January 5, 2023
Subject: Tracy Brook Bridge Replacement
State WIN: 023657.00
Location: **Durham**
Amendment No. 2

Remove Page 15 SOIL NAIL PLAN totaling one page and **Replace** with the attached SOIL NAIL PLAN totaling one page.

SOIL NAIL PLAN

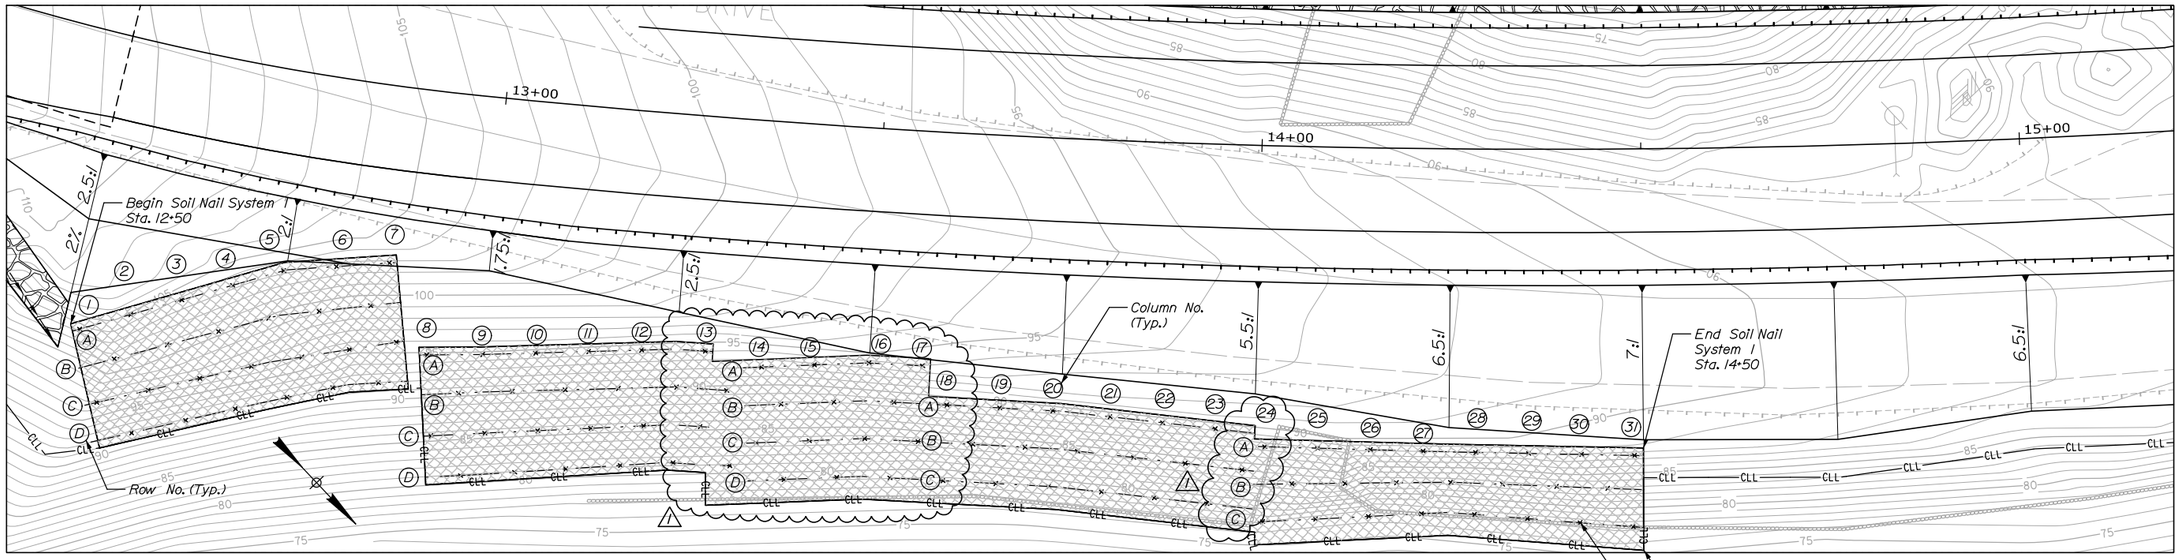
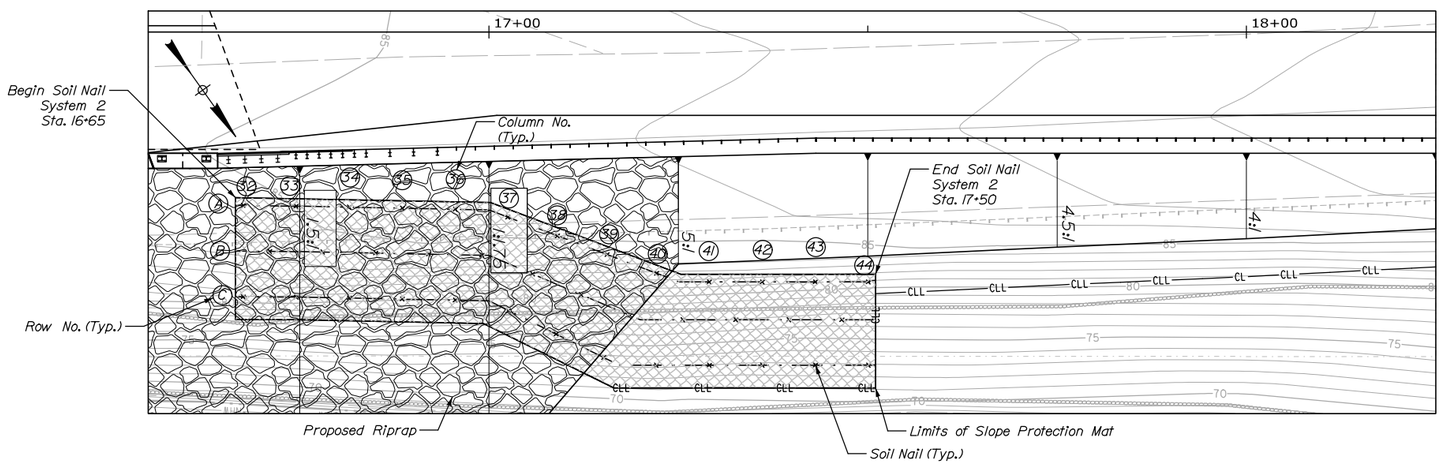
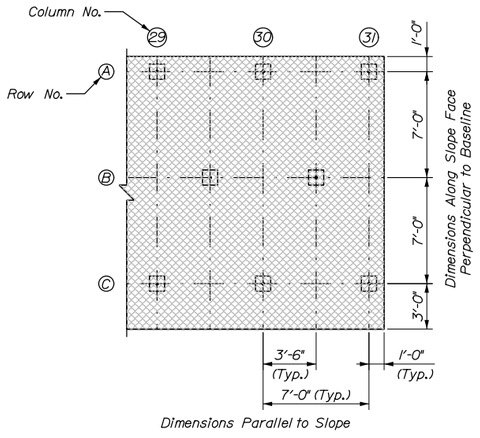
Question: Sheet 15 of the plans shows 3 rows of soil nails between approximate stations 13+31 and 13 +60, but the table on sheet 16 indicates 4 rows in this area. Which is correct?

Response: Four rows of soil nails are required between stations 13+31 and 13+60. Sheet 15 will be revised to reflect the additional soil nails. See revised sheet.
